Re: Town Manager's Report

Subject: Sidewalk Project Design Alternatives

Route 17 between Red Hill Drive and Overlook Road

Technical Review of Alternatives

Option 1 - Fill Wall with 5' Concrete Sidewalks

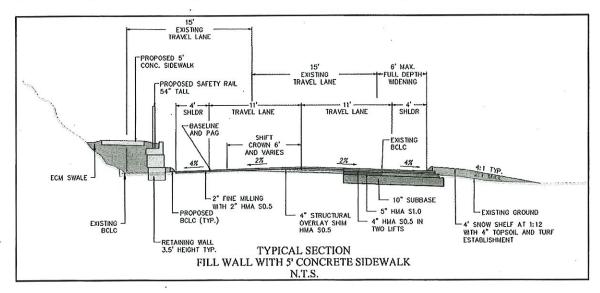
Option 1's 560 foot retaining wall introduces a non-breakaway obstacle well within the clear zone of Route 17. As mentioned in the Highway Design Manual (Figure 2-3F - pg. 2-3(12)), clear zone is a controlling design criteria. Option 1 would violate clear zone for traffic traveling Northbound and Southbound on Route 17, as the wall would be within 20 feet of the roadway in both directions of travel. The Department has concerns about drainage on the proposed sidewalk. The small swale will likely not be able to handle the drainage flowing down the the large cut slope. During winter months, this could cause snowmelt and icing on the sidewalk, creating a safety hazard for pedestrians. The Department also has concerns about the winter maintenance of the roadway, with the retaining wall being proposed so close to the edge of road. Without a snow shelf, snow will be plowed into the shoulder, reducing its effectiveness for a large portion of the winter. In additional, during large snowstorms, there may not be enough room for snow storage, and this could impact the travel lane.

Of the three options presented, the Department recommends **Option 2 - Realignment with 9' Shift and 5' Concrete Sidewalks**. The Department would like to avoid introducing a fixed object in the clear zone. As outlined in the analysis section of this report, the Department has maintenance concerns about the retaining wall and the lack of snow shelf provided with other options. Option 2 is also the only alternative that adheres to all the controlling design criteria outlined in the Highway Design Manual. Option 1 and Option 3 violate the minimum clear zone criteria ((Figure 2-3F - pg. 2-3(12)) with the introduction of a lengthy retaining wall.

Option 2 - Realignment with 9' Shift and 4' Concrete Sidewalks

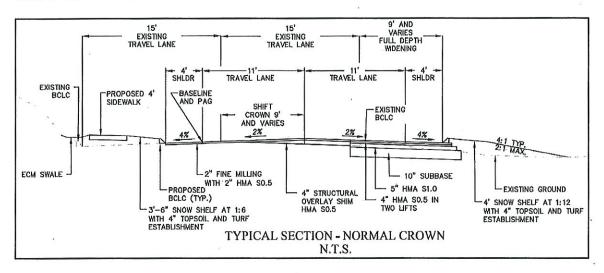
Option 2 requires the most amount of widening of the three options (9 foot maximum). However, this proposed option meets all controlling design criteria outlined in the Highway Design Manual. The existing Highway ROW line is set back far enough that the widening will not require any property acquisitions. A few properties will require grading rights, and there are utility poles that must be relocated to accommodate this option. Option 2 shows a 4-foot sidewalk with a 3.5-foot snow shelf. Although sidewalk width is not a controlling design criteria and 4 feet is the minimum width according to PROWAG, the Department recommends widening the sidewalk to 5 feet, as outlined in Figure 2-3F - pg. 2-3(12) of the Highway Design Manual. 5-foot sidewalks are standard along State highways.

Option 3 - Retaining Wall with 4' Concrete Sidewalks

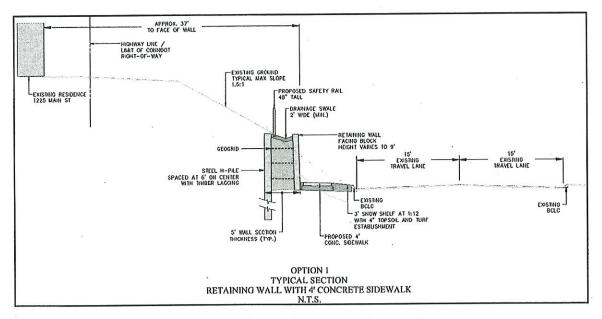
Option 3, similar to Option 1, proposes a retaining wall approximately 500 feet long. This wall is proposed to cut into the existing embankment on the west side of Route 17. The proposed wall, similar to Option 1, introduces a fixed object inside the 20-foot clear zone outlined in the Highway Design Manual (Figure 2-3F - pg. 2-3(12)) for vehicles traveling Southbound on Route 17. This design would violate that controlling design criteria. The proposed wall is set back from the roadway enough to get the retaining wall out of the clear zone for traffic traveling North on Route 17. The Department has a similar recommendation to that of Option 2 where the Department would prefer standard 5-foot sidewalk to better accommodate pedestrians. This alternative requires a maximum widening of 6 feet which can be kept within State right of way.

If Option 2 cannot be accommodated, further coordination between the Town of Glastonbury and the Department would be needed regarding violation of controlling design criteria with respect to Option 1 and Option 3.
